# CITY OF BATAVIA

**DATE:** April 6, 2017  
**TO:** Committee of the Whole - CS  
**FROM:** Gary Holm  
**SUBJECT:** Bike Path Route – Wastewater Treatment Facility

**Subject:** Phase I Wastewater Treatment Plant Improvements – Bike Path

Re: Waste Water Treatment Plant Renovation

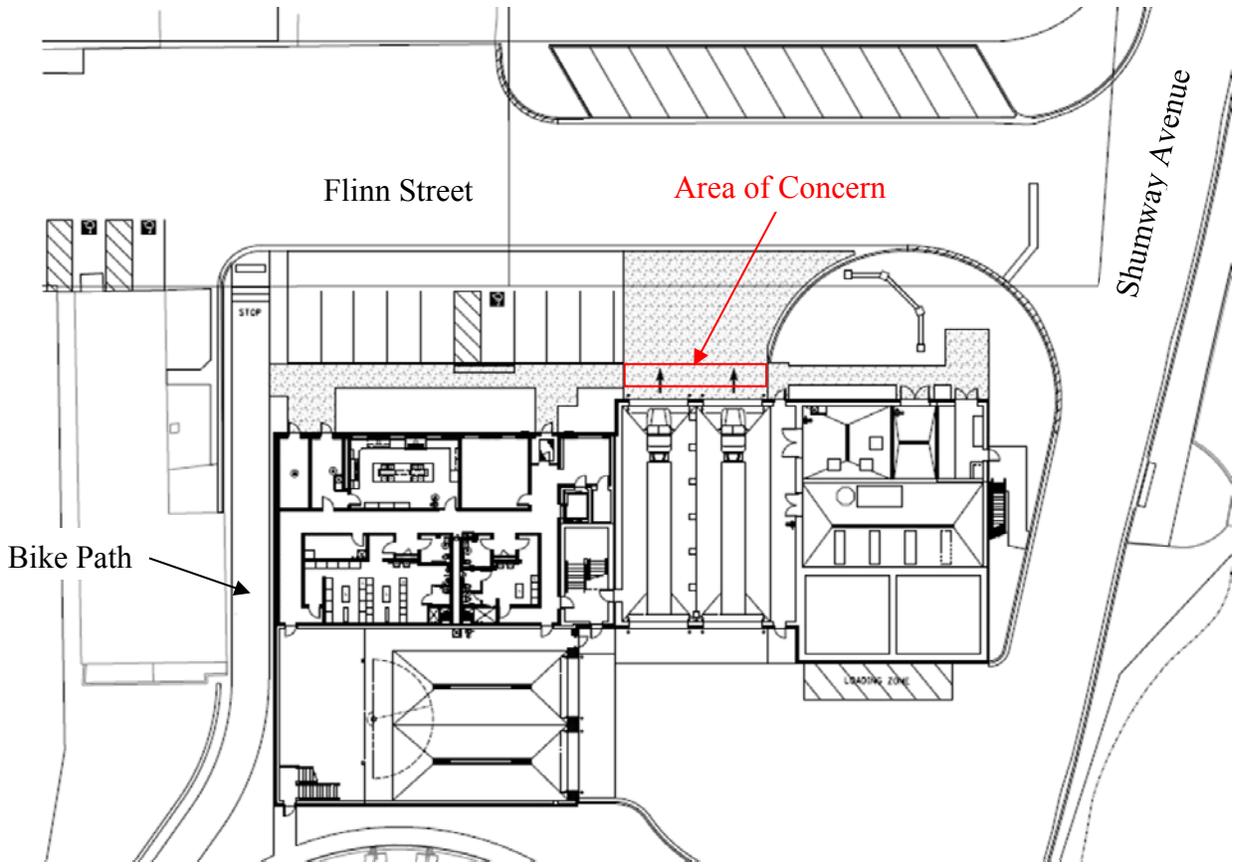
During the City's review of the proposed project, the Bike Commission requested that we consider allowing the sidewalk on the north side of the new Main Building to be connected to the proposed bike path. Alternatively, the discussion included rerouting the bike path between the river and the Treatment Plant.

It is our understanding that the Bike Commission would like the City to utilize the sidewalk adjacent to the north face of the Main Building for the bike path. The City's trucks will access and egress directly from the building. In our opinion, allowing bicyclists to utilize this sidewalk adjacent to the building is a significant safety concern as the semis and straight trucks leaving the building would not have adequate sight distance to avert/avoid a collision with a bicyclist. TAI will not support routing bike traffic to this sidewalk, and its use should be limited to pedestrians accessing the Main Building.

There were several discussions regarding bike path routing during the design process. Early in the design process, consideration was given to rerouting the bike path between the river and the Treatment Plant. Based on available grade, floodplain conditions and existing structures, it was determined that a new bike path along this alignment would need to include elevated or cantilevered platforms such as a boardwalk. While feasible, this alignment was not considered to be practical and presented regulatory and safety issues which would need to be addressed. Other alternatives that were considered included rerouting the bike path along Water Street or creating a new connection with a bike bridge from Quarry Park to the baseball fields on Clark Island. TAI completed similar bike bridges for the Batavia Park District in 2006. At that time, these alternatives were dismissed by the City.

As a result, it was determined that the bike path would maintain its existing alignment along the west edge of the Treatment Plant and the proposed improvements would include regrading of the hill down to Flinn Street. The design team and City considered locating the bike path along the south side of Flinn Street, however safety concerns regarding truck movements and vehicles backing out of parking spots excluded this alternative. An alternative consideration was to install the bike path parallel to Flinn Street on the north side. However, the City requested additional parking for the Food Pantry along the north side. The width of the right of way did not allow installation for both the bike path and parking along the north side of Flinn Street. Therefore, it was determined by City staff that the bike path would share Flinn Street.

If the City would like to reconsider the solution of bicyclists and vehicular traffic sharing Flinn Street, an alternate route must be identified that addresses sight distances and safety concerns. This would require defining a scope of work and developing a separate work order for this project.

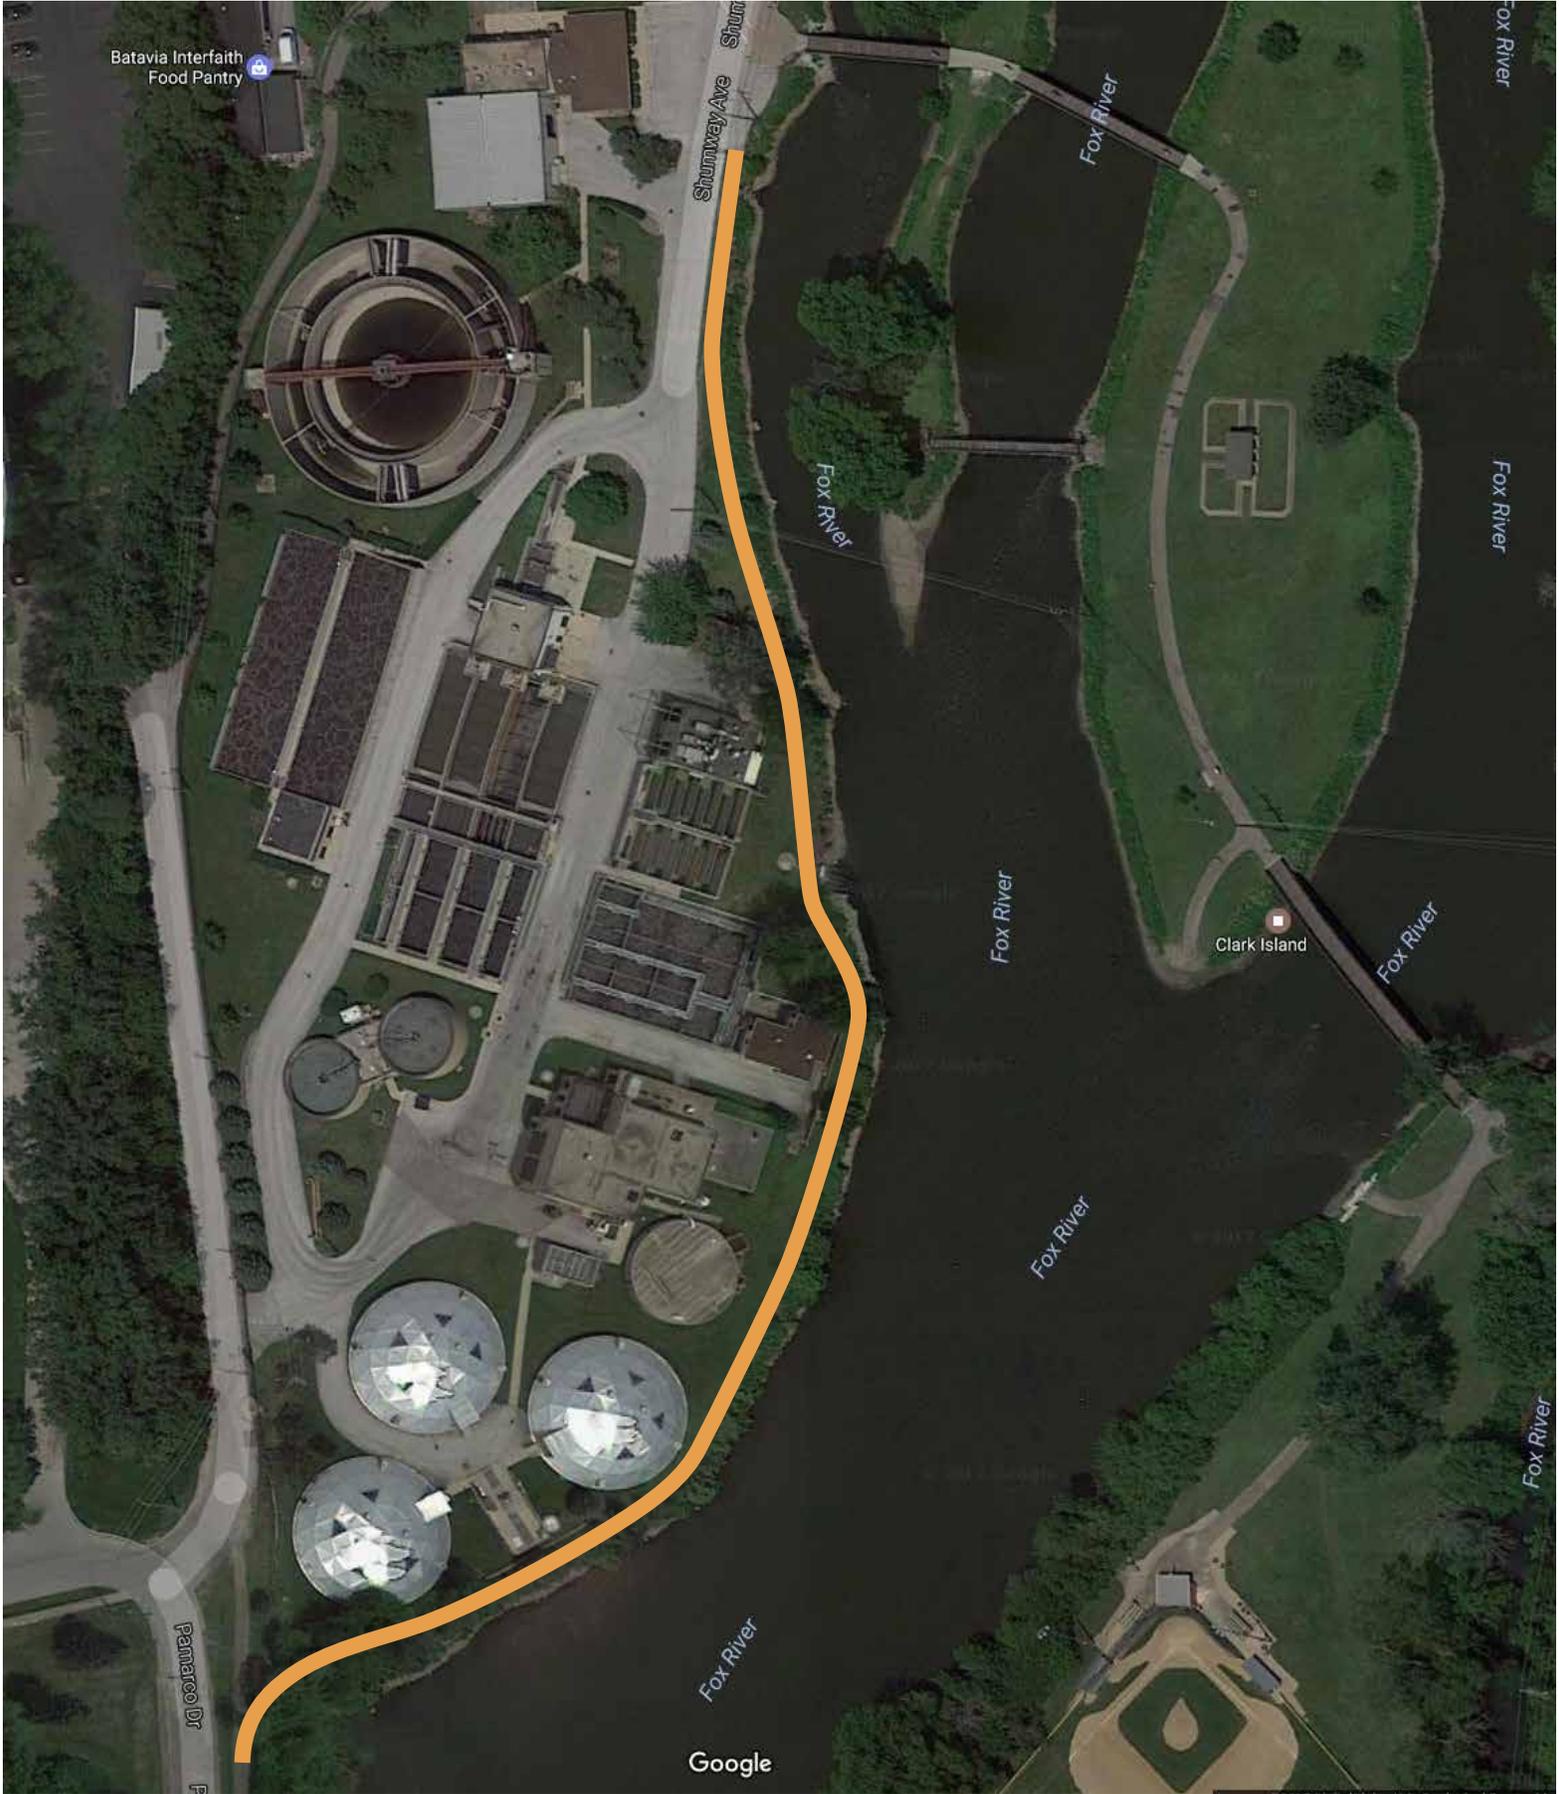
After much discussion, the Bicycle Commission has unanimously decided to recommend that in conjunction with the Wastewater Treatment Plant Improvements the bike path which is currently located along the west and north side of the sewage treatment plant be relocated to the south and east side along the river. The path as it currently exists has not been a very bike friendly route and the proposed plan makes it even worse. It makes sense to correct a problem now rather than make it worse, especially since this is a large overall project and this is a very small part that will have a huge impact on pedestrians, bicyclists and as an entrance to the community for visitors.

There are numerous concerns about the bike path in its current location and the proposed plan not only creates a more hazardous situation. It makes it confusing to navigate routes and provides an unattractive entrance to the town. The current route is already confusing because the route utilizes roads, paths and sidewalks. Good path design should be consistently one material type if possible to encourage and direct riders to remain on a path. The proposed plan would force cyclists onto a city street which is a different surface type and puts them directly behind vehicles backing up and parking. The proposed route also makes an already confusing intersection at Shumway, Flinn and the bridge to Clarke Island even worse. That intersection is already one of the worst for bikes entering town because they do not know which way to go and are usually forced onto Shumway without knowing where it will take them. By moving the path to the north side of Flinn the bridge to Clark Island is out of their range of vision and most cyclists will continue down Shumway and not consider Clarke Island as an option for safe travel. The situation will become worse when the vacant parcel to the North is developed and creates a higher density for the area even if a possible easement could be obtained. Look at how density of the current proposed development at Washington and Wilson, this may be the type of development we will see there in the future. Imagine how hard it may be to get a bike safely through that type of development and density. Again, the Bicycle Commission unanimously thinks the current proposal is unacceptable.

Attached is a proposal that the Bike Commission would like to see adopted. It re-routes the path along the South and East Side of the plant along the river. This proposal solves a number of problems. It keeps bicyclists and pedestrians on a uniform surface rather than routing them onto a private road, path, sidewalk, and city street. It keeps them protected from vehicles trying to park. This proposal keeps bikes off of streets where they have a more pleasant route along the river. No future easement would be required as the vacant land to the north is developed. Also, the connection between Shumway and Clarke Island would be very logical. Considering the scope of the entire Wastewater Treatment Plant Project, we feel now would be the best time to make changes that will affect bicycle travel and safety for decades in the future. The bike path is one of the treasures of Batavia that makes this community unique. I would be happy to discuss further or any questions.
